APPEAL OF IMPROPER CEQA CATEGORICAL EXEMPTION
2417 GREEN STREET PROJECT, SAN FRANCISCO
IMMINENT FOUNDATION & SIDEWALL DAMAGES
TO THE UNIQUE
HISTORICAL RESOURCE AT 2421 GREEN STREET
ENVIRONMENTAL IMPACT REPORT REQUIRED

January 9, 2018

Subject: Appeal of Improper CEQA Categorical Exemption

2417 Green Street Project [Block 560 - Lot 028]

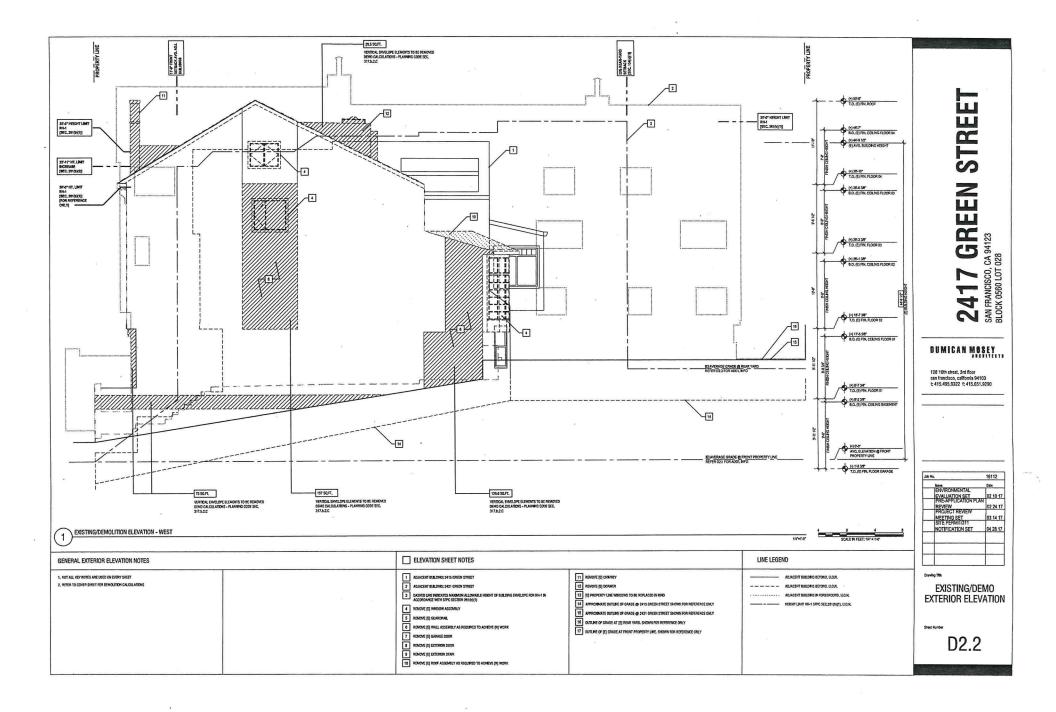
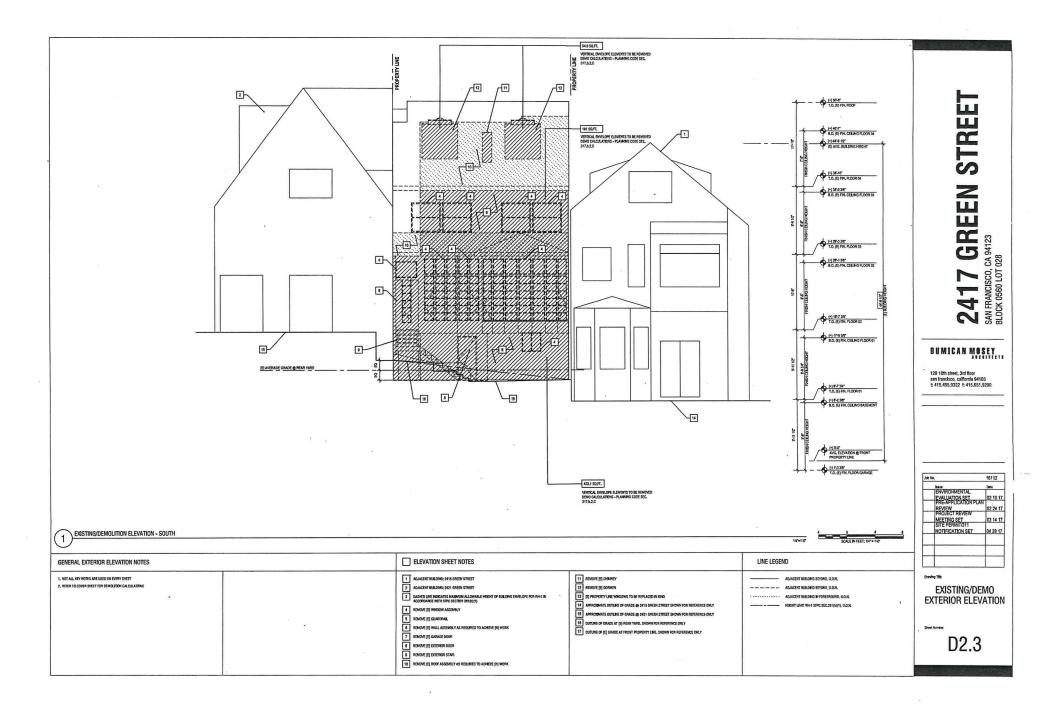
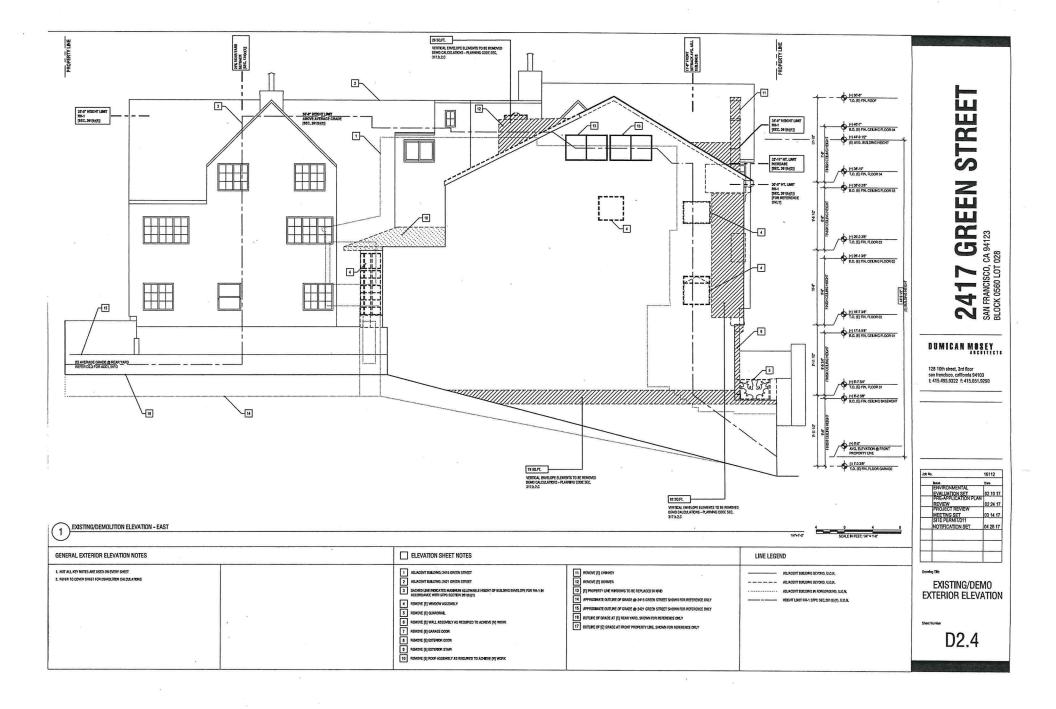
The 2417 Green architectural sidewall elevations that are said to show a comparison between "Existing" and "Proposed" floor plans again suffer from lack of grid lines plus superposition of demolition areas (instead of creating separate drawings from the CAD files). Areas of 2417 Green enlargement that affect the historic Coxhead House are highlighted in yellow (Attachment D).

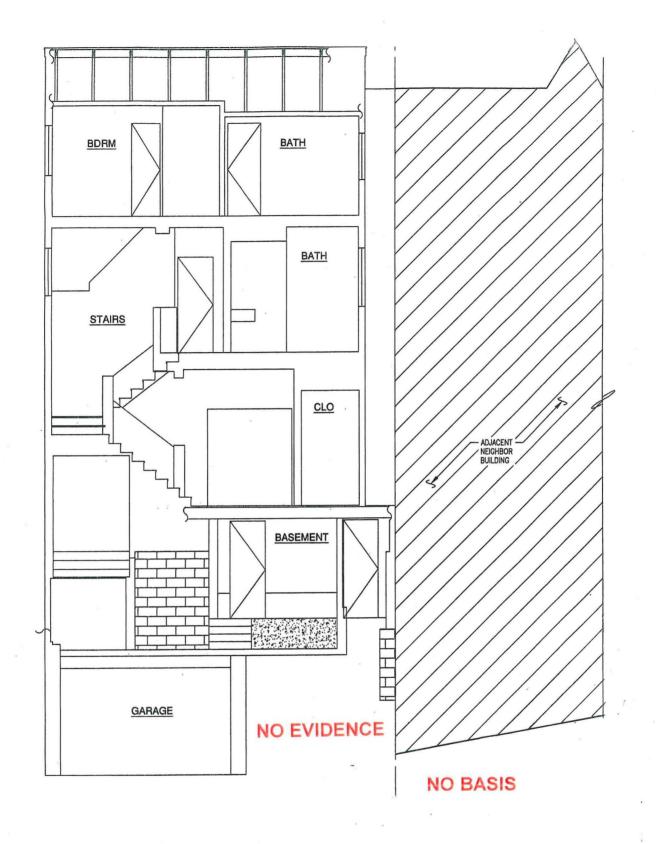
Having been involved with shoring and underpinning design and construction in San Francisco since the 1950s, it is obvious to me that the 5/5/17 drawings (i.e. Sheet S4.1) were faked to show the foundations for the contiguous 2421 Green extending much deeper into the ground than the garage expansion at 2417 Green.

Sheet S4.1: Shows three transverse sections through 2417 and partially through the neighboring buildings that are not oriented ("looking north" or "looking south") but their orientation can be determined from the plans and the elevation (north) that shows the slope of Green Street and the location of the existing garage. Totally lacking in detailing of underpinning and shoring of the foundations of the Coxhead House required by 2016 SFBC §3307, 1803.5.7. The following discusses the three specific sections shown on Sheet S4.1:

Shows extensive excavation and new construction along property line of 2421. Although not oriented by reference on the Sheet, the section is cut on S2.1 as looking north (switch from other transverse sections on Sheet S4.1 which are looking south).
